# Access Compliance Report

## Public Rights-of-Way

Intersection ID: 30476	Main Street: CREEK_TURN_DR	Cross Street: PLANTERS_ROW_DR	Location: SE
ADA ID: A17662F6C75F	Ramp Type: PerpDiag	Initial Pass/Fail: Fail	Overall Compliance: No
Severity Score: 21.25			
Codes/Mitigation Info/Possible Solution		Field Measurements/Component Compliance

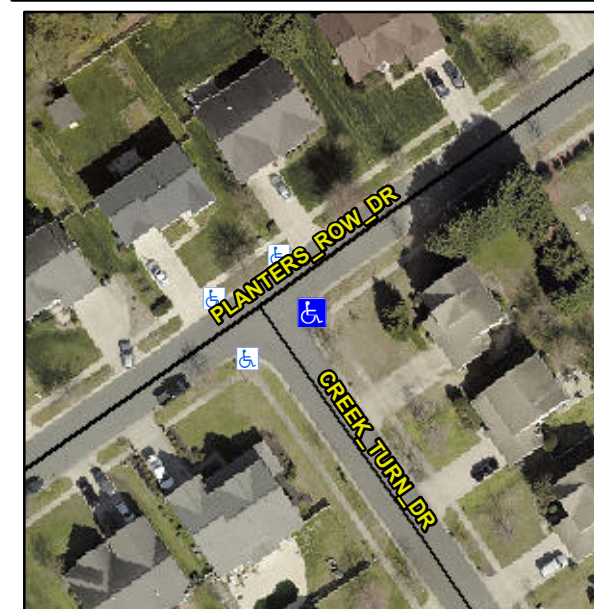
**Not Found, R304.5.1, R304.2.2**

Compliance	Description	Data	Compliance	Description	Data
N/A	Ramp Length (in)	85.0	No	Ramp Slope (%)	9.9
No	Ramp Width (in)	36.0	Yes	Ramp XSlope (%)	1.6
N/A	Flare Type LT	N/A	N/A	Flare Type RT	N/A
N/A	Flare Slope LT (%)	N/A	N/A	Flare Slope RT (%)	N/A
N/A	Flare Traversable LT?	N/A	N/A	Flare Traversable RT?	N/A
N/A	Landing Length (in)	N/A	N/A	DWS Provided?	N/A
N/A	Landing Width (in)	N/A	N/A	DWS Contrast?	N/A
N/A	Landing Slope (%)	N/A	N/A	DWS Length (in)	N/A
N/A	Landing X Slope (%)	N/A	N/A	DWS Full Width?	N/A
N/A	Landing Curb? (Y/N)	N/A	N/A	DWS Offset (in)	N/A
N/A	Shared Landing?	N/A			
N/A	Gutter Ponding?	N/A	N/A	Gutter Slope (%)	N/A
N/A	Gutter Lip Ht (in)	N/A	N/A	Gutter X Slope (%)	N/A
N/A	Painted X Walk1?	No	N/A	Painted X Walk2?	No
	X Walk 1 Direction	To NW		X Walk 2 Direction	To SW
N/A	X Walk 1 Width (in)	N/A	N/A	X Walk 2 Width (in)	N/A
	X Walk 1 Slope (%)	0.3		X Walk 2 Slope (%)	2.8
	X Walk 1 X Slope (%)	1.8		X Walk 2 X Slope (%)	2.2

**Remove & Replace Curb Ramp With Two New Directional Ramps or Equivalent.**
